ADDRESS: 1907 GREEN ST

Proposal: Demolish rear three-story addition; construct three-story addition and roof deck

Review Requested: Final Approval

From: Nic Tanji <nic@pace-ad.com>
Sent: Thursday, December 4, 2025 9:56 AM
To: preservation; Heather Hendrickson; Kim Chantry
Cc: Ben Estepani
Subject: RE: 1907 Green St PHC application
Attachments: 1907 Green St Rear Wall Scope Assessment 12-3-25.pdf; 251204 - 1907 Green St - PHC Revision 01.pdf

Ⓑ BASEMENT DEMOLITION PLAN
3/32" = 1'-0"

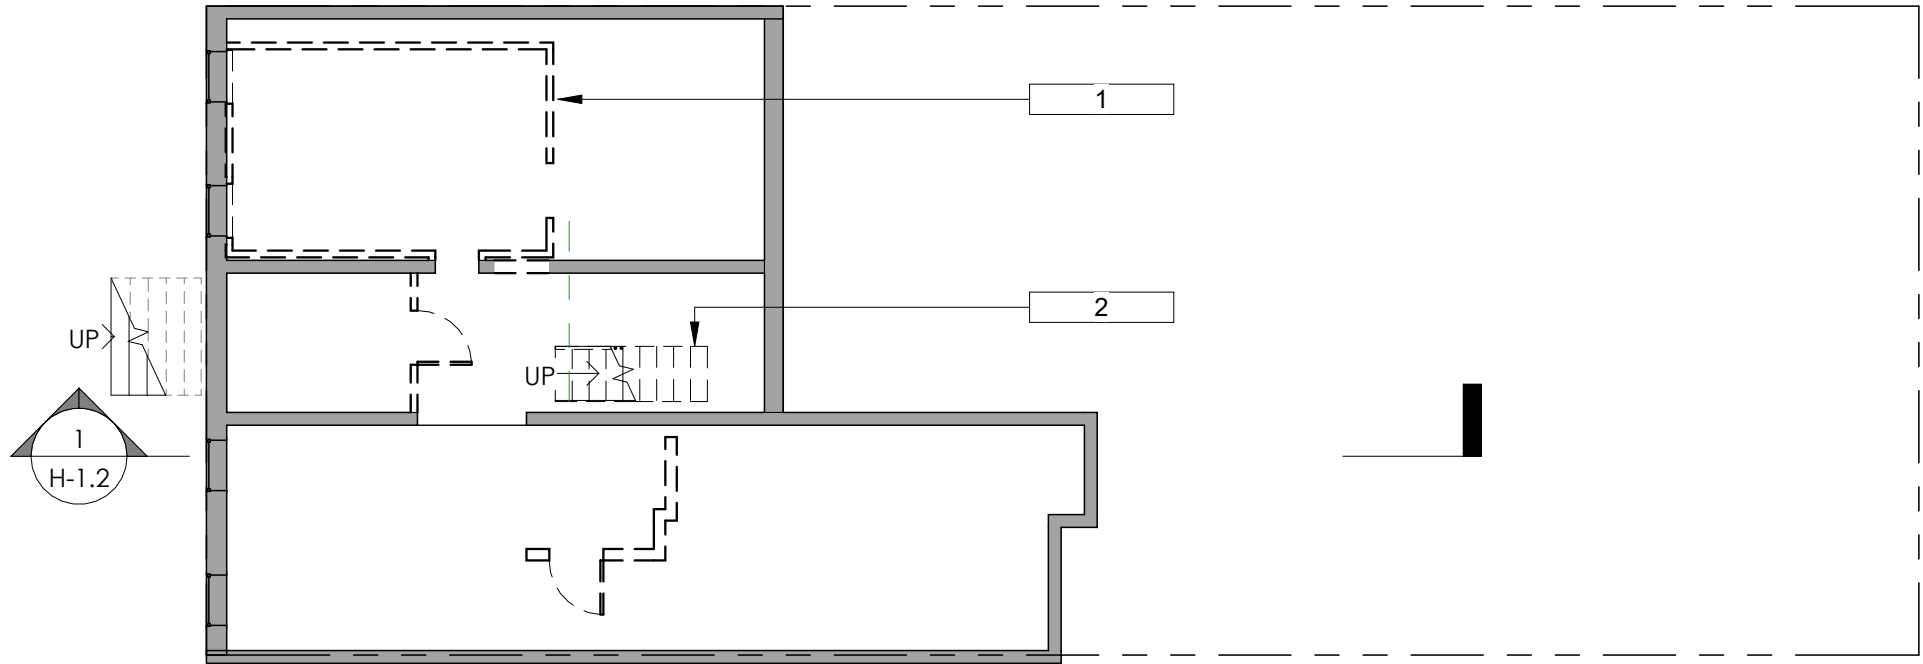
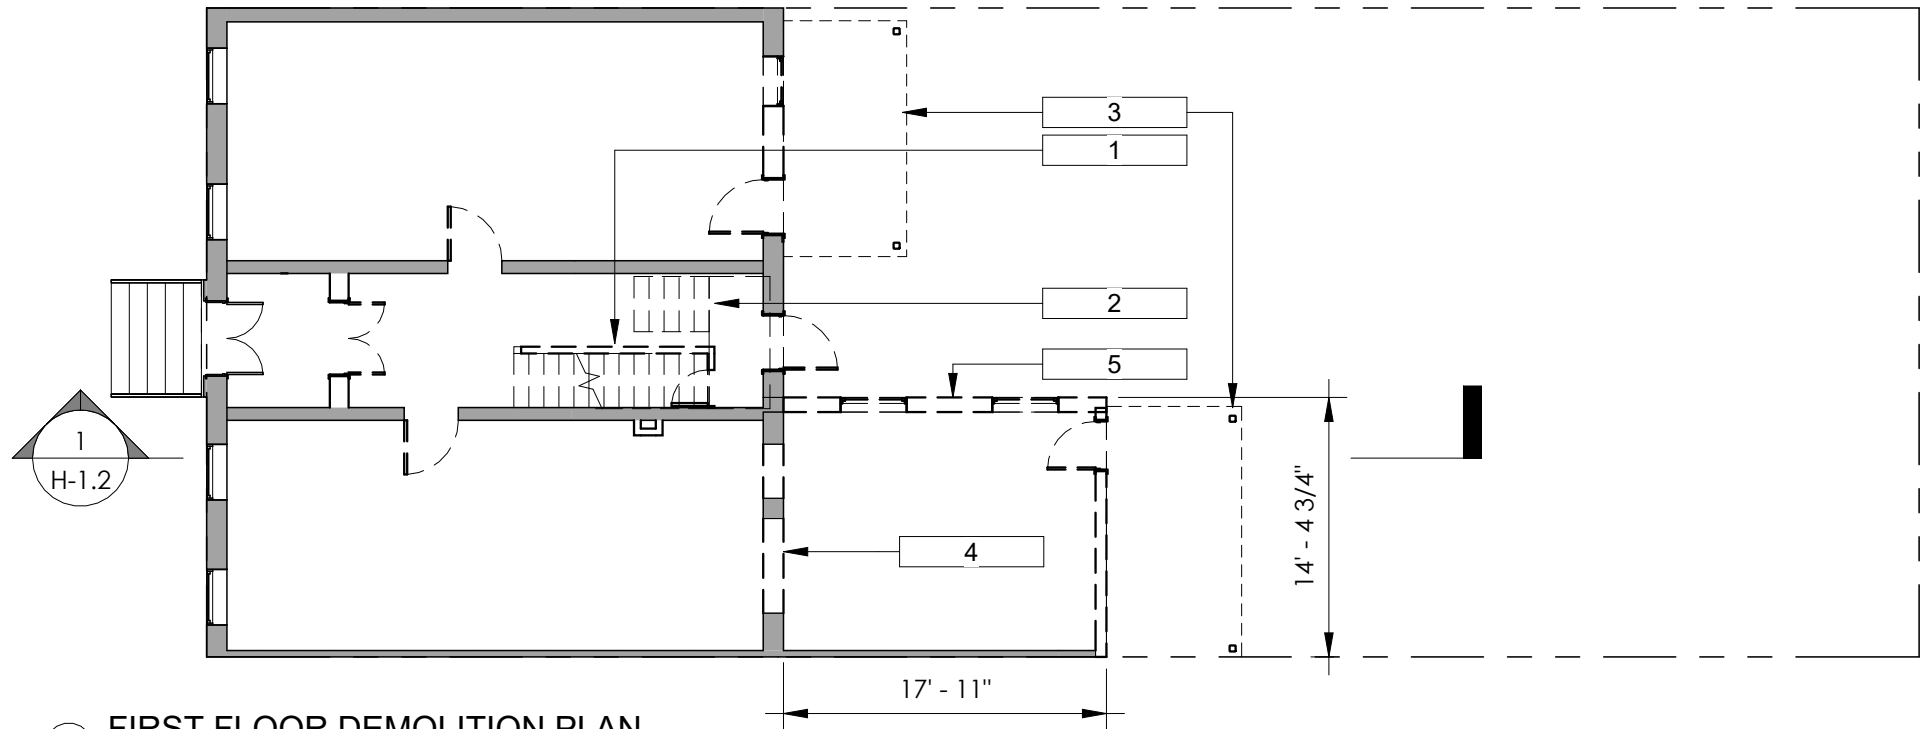
- **H1.0-1.1** – Demo plans reflect portions of existing masonry wall at the rear façade of the main building remaining, per guidance from initial PHC meeting regarding structural concerns associated with complete demo of the masonry wall.

1. DEMO INTERIOR NON-LOAD BEARING WALLS, TYP.
2. DEMO INTERIOR NON-COMPLIANT STAIRS, TYP.
3. DEMO NON-ORIGINAL DECKS.
4. DEMO PRIMARY BUILDING REAR FACADE.
5. DEMO 3-STORY REAR PORTION OF BUILDING.

1. DEMO INTERIOR NON-LOAD BEARING WALLS PER PLAN.
2. DEMO INTERIOR NON-COMPLIANT STAIRS, TYP.
3. DEMO NON-ORIGINAL DECKS.
4. DEMO PORTIONS OF (E) REAR MASONRY WALL, SEE H-1.3.
5. DEMO 3-STORY REAR PORTION OF BUILDING.

② SECOND FLOOR DEMOLITION PLAN
3/32" = 1'-0"

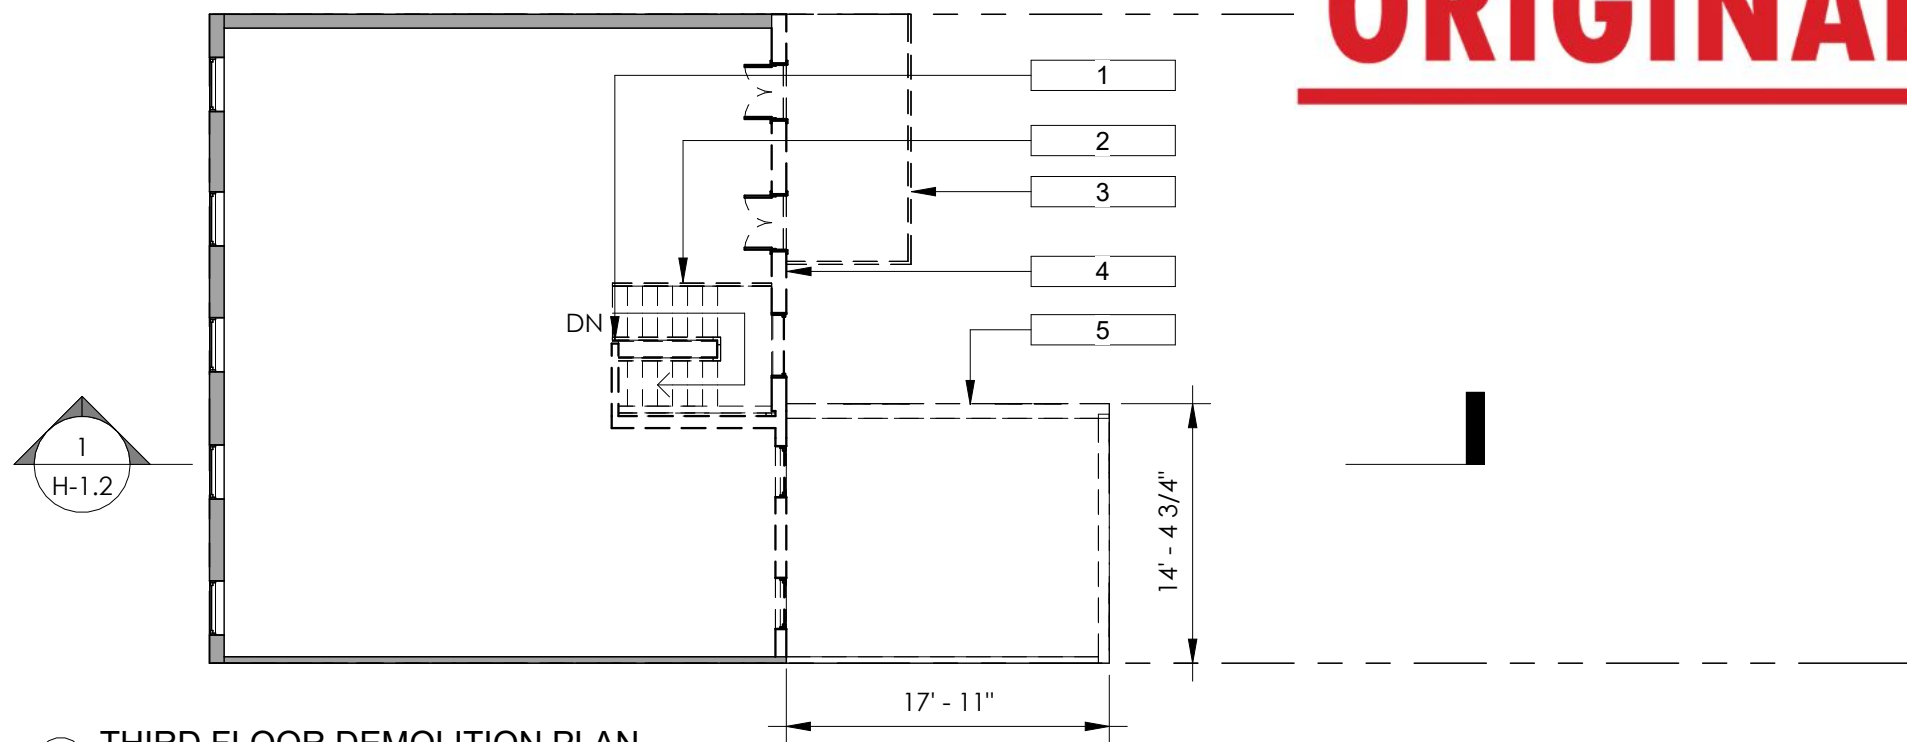
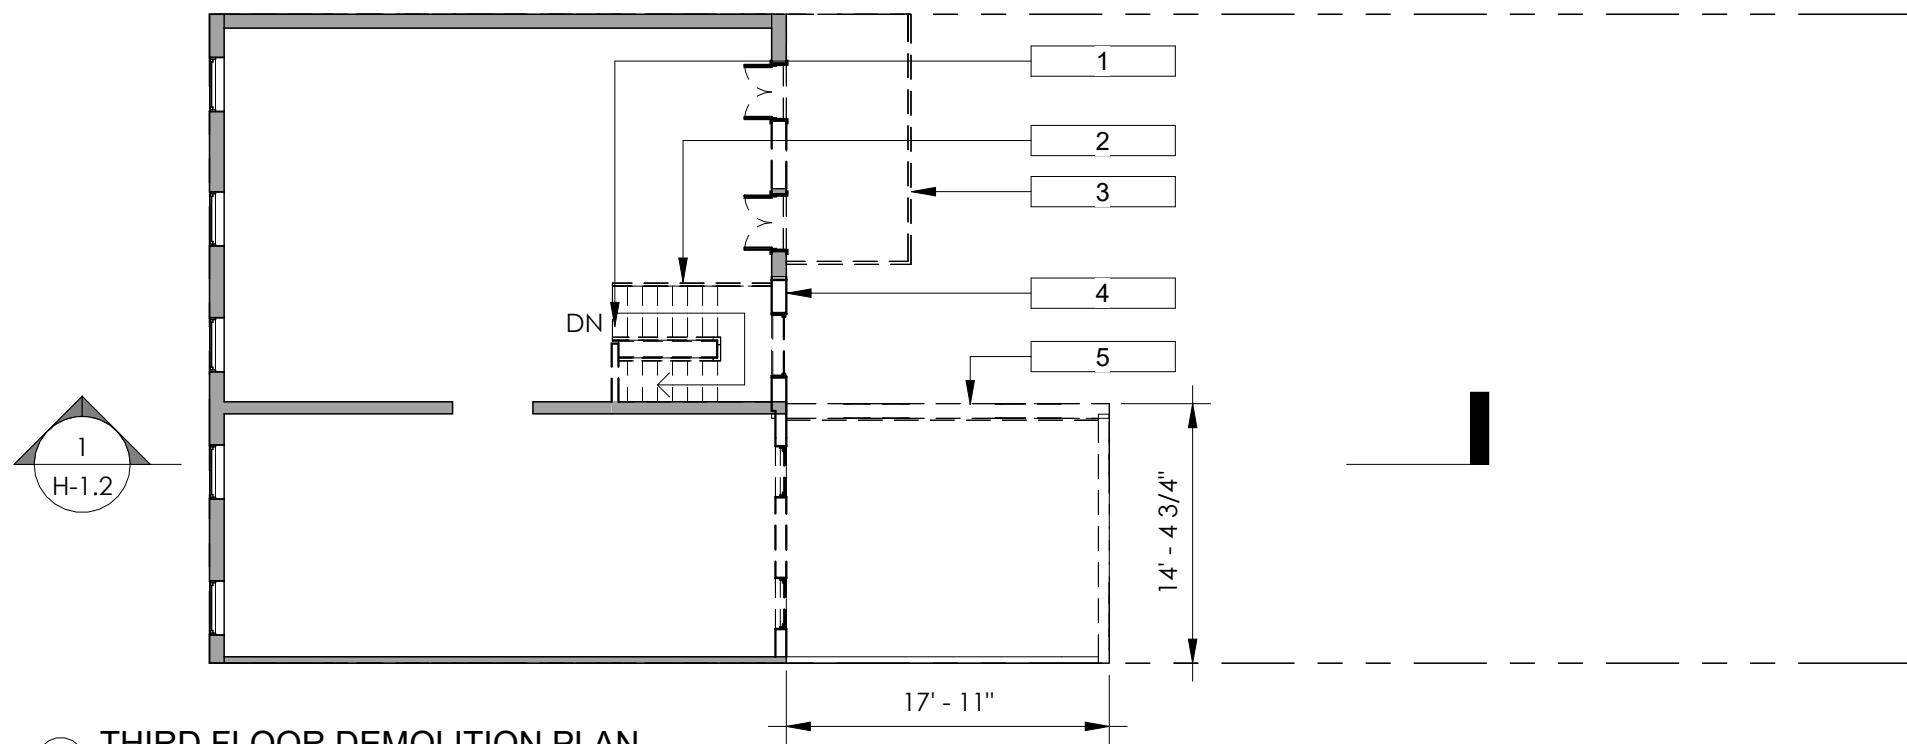
1. DEMO INTERIOR NON-LOAD BEARING WALLS, TYP.
2. DEMO INTERIOR NON-COMPLIANT STAIRS, TYP.
3. DEMO NON-ORIGINAL DECKS.
4. DEMO PRIMARY BUILDING REAR FACADE.
5. DEMO 3-STORY REAR PORTION OF BUILDING.

1. DEMO INTERIOR NON-LOAD BEARING WALLS PER PLAN.
2. DEMO INTERIOR NON-COMPLIANT STAIRS, TYP.
3. DEMO NON-ORIGINAL DECKS.
4. DEMO PORTIONS OF (E) REAR MASONRY WALL, SEE H-1.3.
5. DEMO 3-STORY REAR PORTION OF BUILDING.

① REAR ELEVATION DEMO DIAGRAM
3/16" = 1'-0"

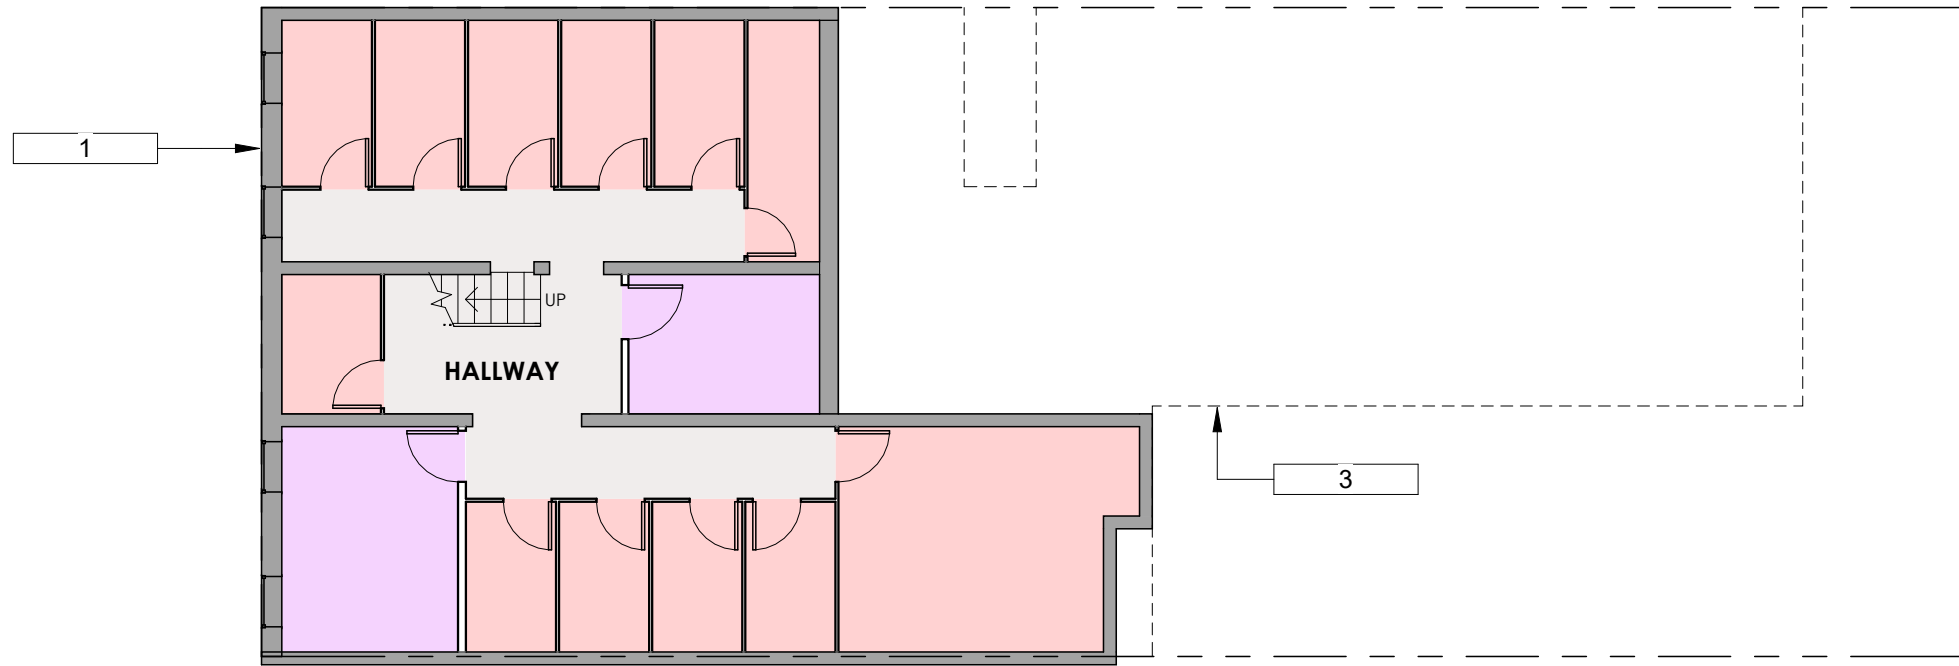
- **H1.3** – Additional elevation diagram illustrating extents of demo and salvage in the existing masonry wall at the rear façade of the main building. The current plans propose preserving over 50% of the existing masonry wall area, and align the extents of demo, where possible, with existing openings in the wall.

~380 SF OF ORIGINAL BRICK TO REMAIN

① PROPOSED REAR ELEVATION
1/8" = 1'-0"

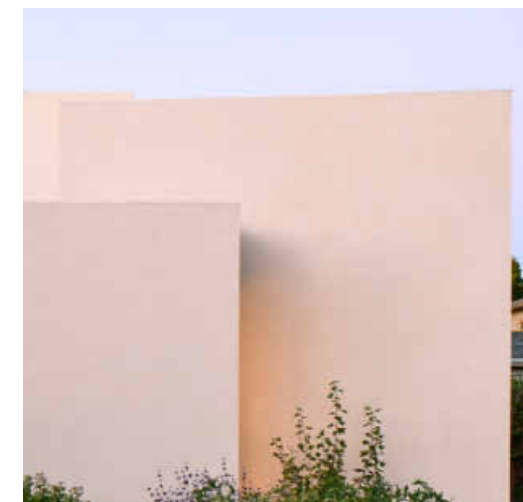
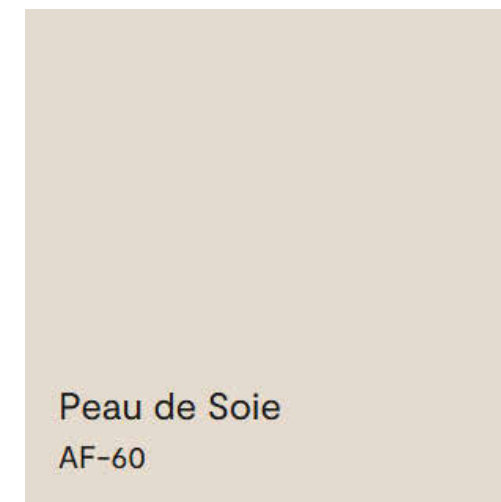
- **H1.4-1.5** – Proposed plans reflect impacts of preservation of existing masonry wall at Units #1, 2, 4, 5, 7 and central circulation corridor.
- **H2.3-2.4** – Proposed elevations and rendering have been revised to reflect direction from initial PHC meeting to make the new addition look like a masonry building by replacing all siding with stucco.

JAMES HARDIE ARTISAN SIDING, OR SIM.
PAINTED FINISH

STUCCO
PAINTED OR INTEGRAL COLOR FINISH TBD
